Subject: Exelon Nuclear Texas Holdings, LLC
Victoria County Station Early Site Permit Application
Response to Request for Additional Information Letter No. 09
NRC Docket No. 52-042

Attached are responses to NRC staff questions included in Request for Additional Information (RAI) Letter No. 09, dated May 6, 2011, related to Early Site Permit Application (ESPA), Part 2, Sections 02.05.01 and 02.05.03. NRC RAI Letter No. 09 contained twenty-three (23) Questions. This submittal comprises a partial response to RAI Letter No. 09, and includes responses to the following six (6) Questions:

Figure 1. Location of Fault E LiDAR Profiles.

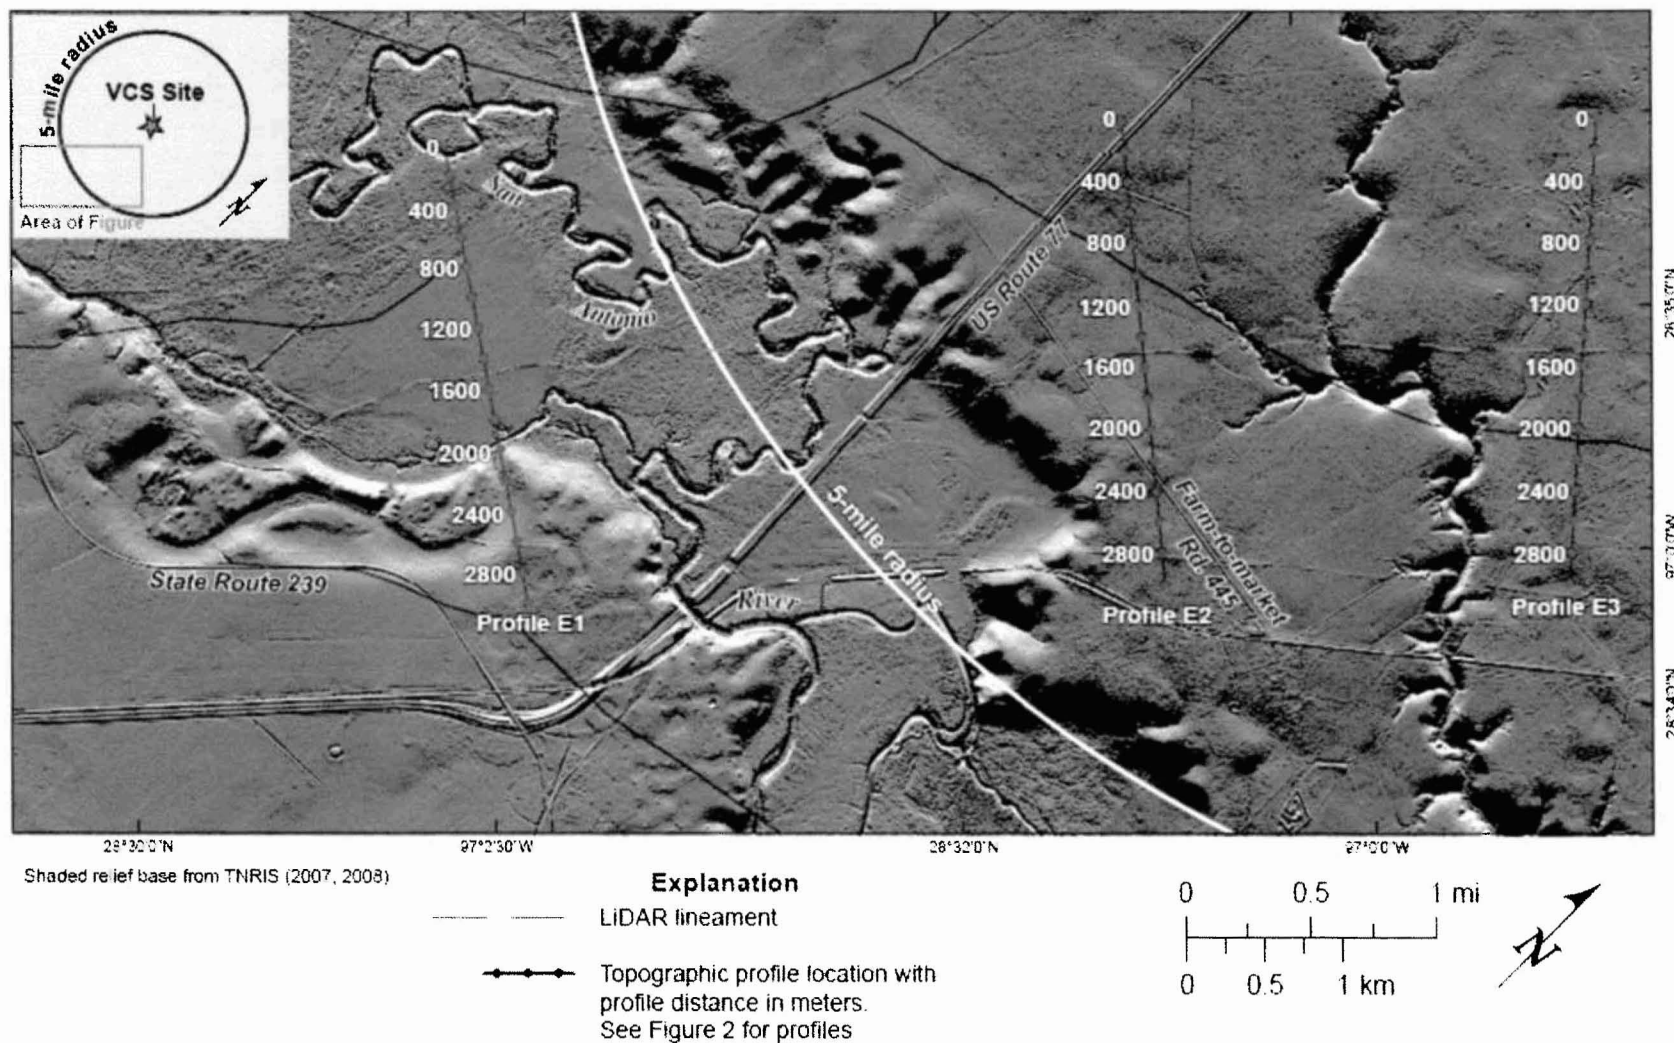
SSAR Section 2.5.1.2.4.2.4 describes fault E as having a similar geomorphic expression as fault D, which may imply that faults D and E are splays and may share a similar, contemporaneous movement history. In support of 10 CFR 100.23, please plot one or more representative LiDAR topographic profiles of faults D and E side-by-side, at the same scale and vertical exaggeration, to facilitate comparisons of their geomorphic expressions.

This similarity between the faults can be seen in Figure 2 of this RAI response, which shows topographic profiles from the LiDAR data (TNRIS, 2007, 2008) presented in the SSAR across both growth faults E and D. The profiles from growth fault D are a subset of those shown in SSAR Figure 2.5.1-50, and the locations of those profiles are shown in SSAR Figure 2.5.1-49. The growth fault E profiles were developed explicitly for this RAI response, and the locations of the profiles are shown in Figure 1.
